UNITED STATES PATENT AND TRADEMARK OFFICE

APPLICATION NO.	FILING DATE	FIRST NAMED INVENTOR	ATTORNEY DOCKET NO.	CONFIRMATION NO.
10/671,174	09/24/2003	Carolina H. Henderson	CH-03-01	7005
27625	7590	07/12/2005	EXAMINER	
MARIAN J. FURST 988 SYCAMORE AVENUE BOULDER, CO 80303			BOGART, MICHAEL G	
			ART UNIT	PAPER NUMBER
			3761

Office Action Summary

DETAILED ACTION

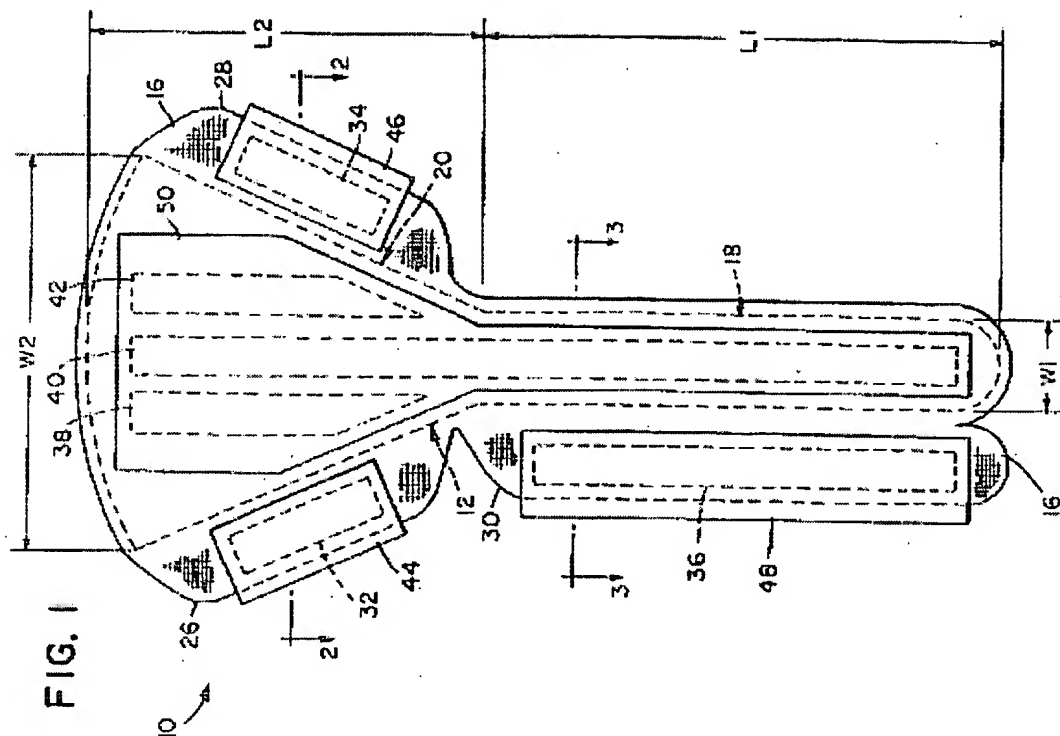
Regarding claim 1, Sturino teaches a feminine hygiene article (10) for absorption of bodily fluids, comprising:

an elongated absorbent article (10) having a front end (20), a back end (18), a length (L1, L2) between said front and back ends (20, 18) sufficient to extend from a point between the user's buttocks to a point beyond the user's urogenital area, a height less than about 2 inches, and a width sufficiently small to fit between the user's buttocks and legs without causing significant discomfort;

wherein said article (10) is formed such that said back end can be inserted between and retained in position by a user's buttocks while said front end (20) extends forward beyond the user's urogenital area, and does not include an intravaginal portion (column 2, lines 25-41)(see figure 1, below).

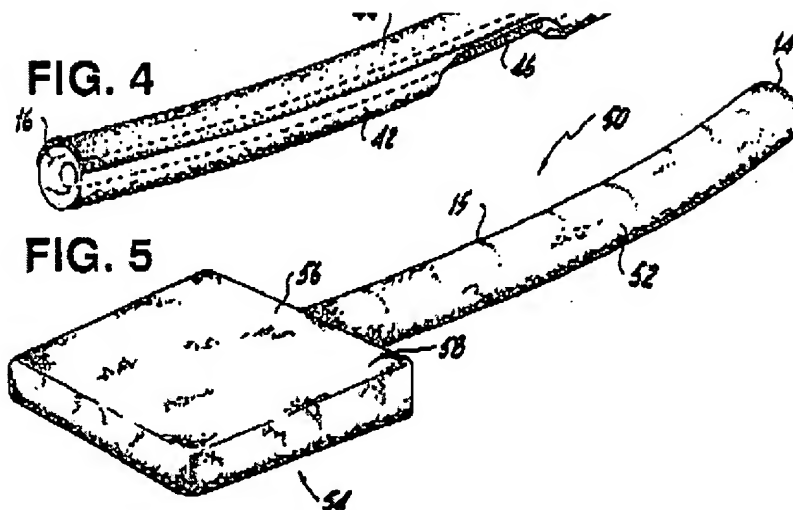
Claim 10 is rejected under 35 U.S.C. § 103(a) as being unpatentable over Sturino.

Sturino does not expressly disclose an absorbent article having a height between 0.5 and 1.5 inches.

Mere changes in size alone are not sufficient to patentably distinguish a claimed invention from what is known in the art. *In Gardner v. TEC Systems, Inc.*, 725 F.2d 1338, 220 USPQ 777 (Fed. Cir. 1984), cert. denied, 469 U.S. 830, 225 USPQ 232 (1984), the Federal Circuit held that, where the only difference between the prior art and the claims was a recitation of relative dimensions of the claimed device and a device having the claimed relative dimensions would not perform differently than the prior art device, the claimed device was not patentably distinct from the prior art device. MPEP § 2144.04.

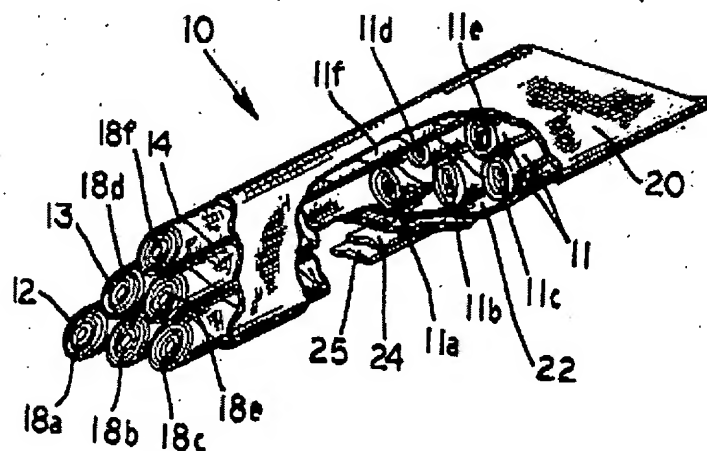
Regarding claim 1, White teaches a feminine hygiene article (10) for absorption of bodily fluids, comprising:

an elongated absorbent article (10) having a front end (54), a back end (14), a length between said front and back ends (54, 14) sufficient to extend from a point between the user's buttocks to a point beyond the user's urogenital area and a width sufficiently small to fit between the user's buttocks and legs without causing significant discomfort;

wherein said article (10) is formed such that said back end (14) can be inserted between and retained in position by a user's buttocks while said front end (54) extends forward beyond the user's urogenital area, and does not include an intravaginal portion (Abstract)(see figure 5, below).

White teaches an elongated cylinder that can be made of gauze, etc., , but does not expressly teach that is composed of a coiled material.
